## Arlington Conservation Commission

**Date:** Thursday, February 3, 2022

- 8:30 p.m. **1. Notice of Intent: Hurd Field (Continued)**  
**DEP #091-0337**  
Documents: Hurd Field Response to Comments

**Reference: Response to NOI Comments**  
**Town of Arlington Hurd Field Renovation MassDEP File No 091-0337**

Drawing No.  
L-5

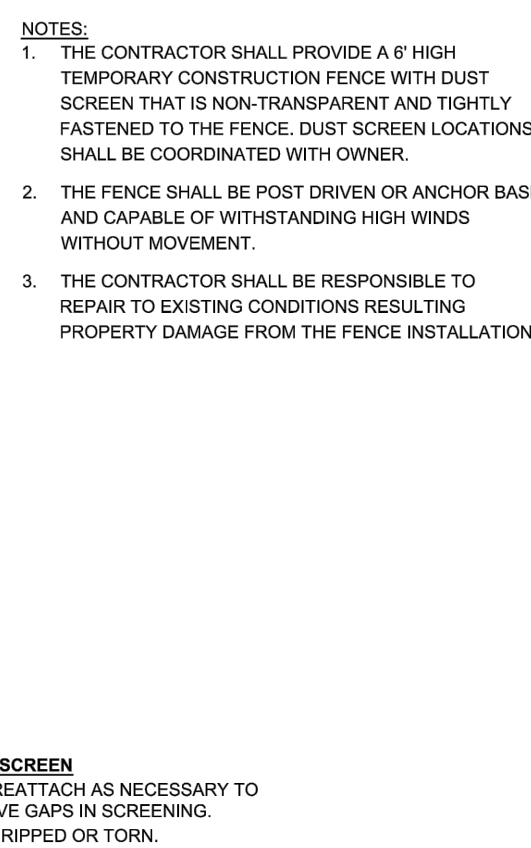
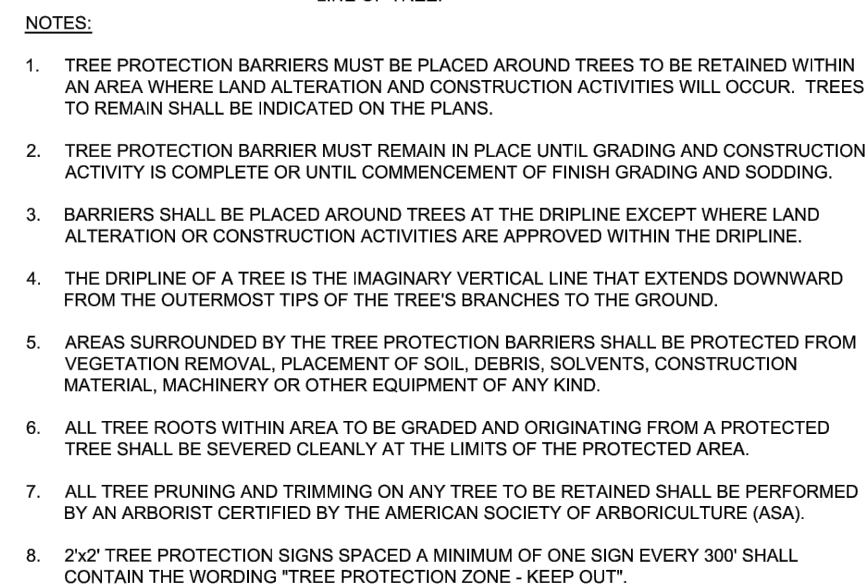
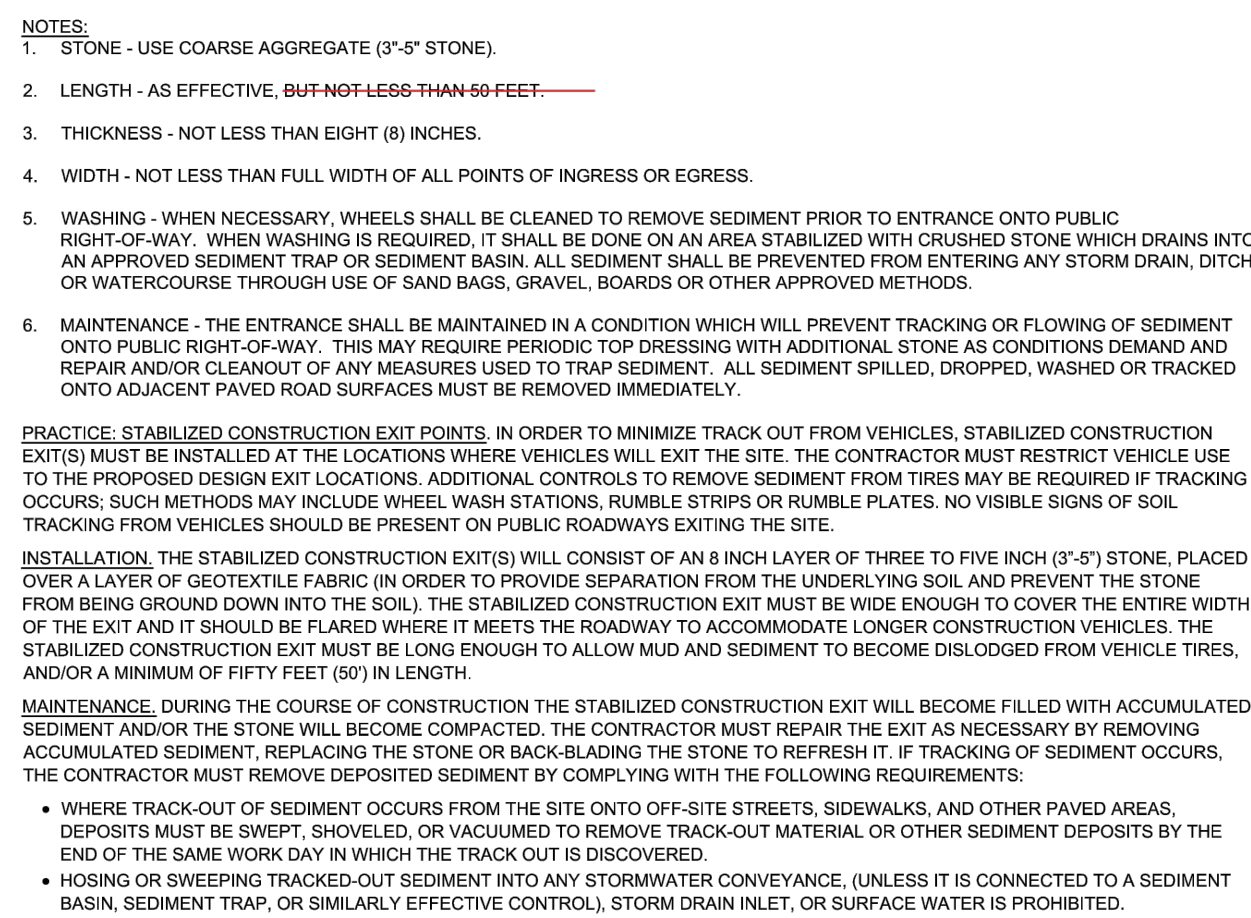
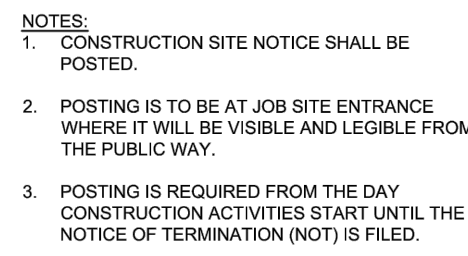
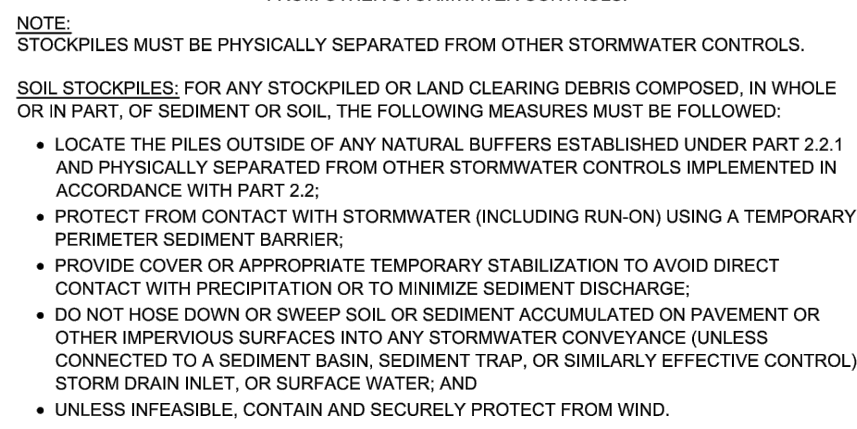
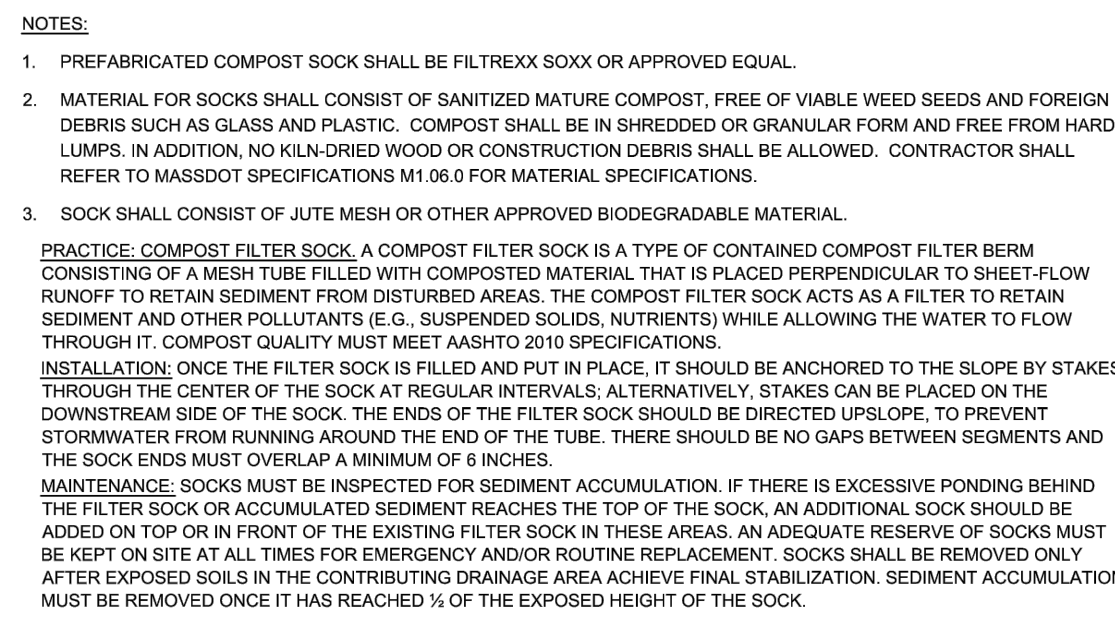
*The path along the northwestern side that connects the Minute Man bike path to the Arlington Reservoir has been moved out of the 25' Adjacent Upland Resource Area (AURA). The loop path on the eastern side needed to be partially removed to allow for the change and still have the soccer field size program needed. The path ends in the east before it reaches the 25' AURA. The northern portion of the loop path has been removed. The volume of flood storage is now proposed to be approximately 904 CY more than the existing condition. In addition, the proposed light pole is now out of the 25' AURA. Planting has been added with 18 new trees and a meadow restoration seed mix in the majority of swales, where applicable, as well as the low point/ retention area. Invasive species are prevalent along the edge of the river. The Recreation Department is unable to develop a comprehensive invasive species management plan for this particular project currently as it is*

The path along the west side of the fields will be within the same alignment as the existing path and/or slightly closer to the river. Compared to the previous design, the majority of the path to the east and north of the fields has been shortened and/or eliminated in the proposed re-design. A short section of path to the east will remain in riverfront area to provide ADA compliant access to the eastern most field. A section of the path on north will be eliminated with exception of connection to existing path over the river and to the reservoir. See attached revised plan set.
